CORPORATE REPORT

From: David Bennett, Planner II File No: 3060-20-2019-02

Subject: Aquadel Crossing Ltd. applied to amend an existing Development Permit (relating to form and character) to permit fencing across common strata property at the development known as Aquadel Crossing, 1885 Columbia Valley Road, Electoral Area "H".

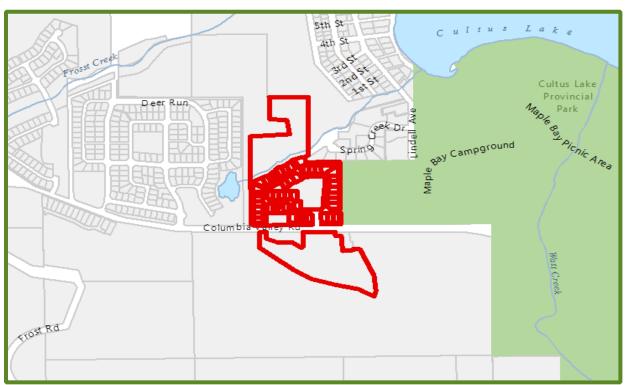
The image above shows the design and material of fencing proposed and how the fences would cut across common strata land within the strata subdivision. The bulk mulched area with plantings is common strata property. The individual's strata lot ends where the grass ends. This common strata property acts as a buffer from neighbouring developments and it is a requirement of the zoning bylaw.

In other areas, the developer is proposing to install dense cedar hedging across the common strata areas as shown above. The bulk mulched area with plantings is common strata property and it forms the buffer between the Aquadel development and adjacent lands. The individual's strata lot ends where the grass ends.

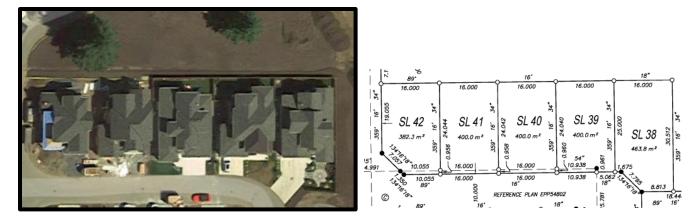
The image above highlights the location of the buffer areas around the perimeter of the development.

As shown in the Google Earth image above, fences installed around the perimeter of strata lots achieves the separation between individual units in the development. There is no concern with strata lot owners fencing along their own lot lines. Lots #38 to 42 are fenced along the boundary of the strata lots and do not extend the rear yards into the adjacent common strata lands. An extract of the subdivision plan is shown above.

The Google Earth image below shows buffer areas are not being maintained equally. In this image, the strata lot #4 increased the lawn area into the required buffer area. Strata lot #7 has installed fences to the north bumping out into a common strata walkway.

The installation of cross fencing has already shown that the landscaping is not maintained equally throughout this development. The cross fences impede access to the common strata lands which in turn does not allow the strata to inspect and maintain the vegetation. The common strata buffer spaces need to be open in order for the strata to perform inspections to ensure maintenance is undertaken properly. To ensure uniform compliance, the maintenance of the common strata lands should be the responsibility of the strata. The images above show that the common strata buffer spaces are not being maintained the same by all lot owners.
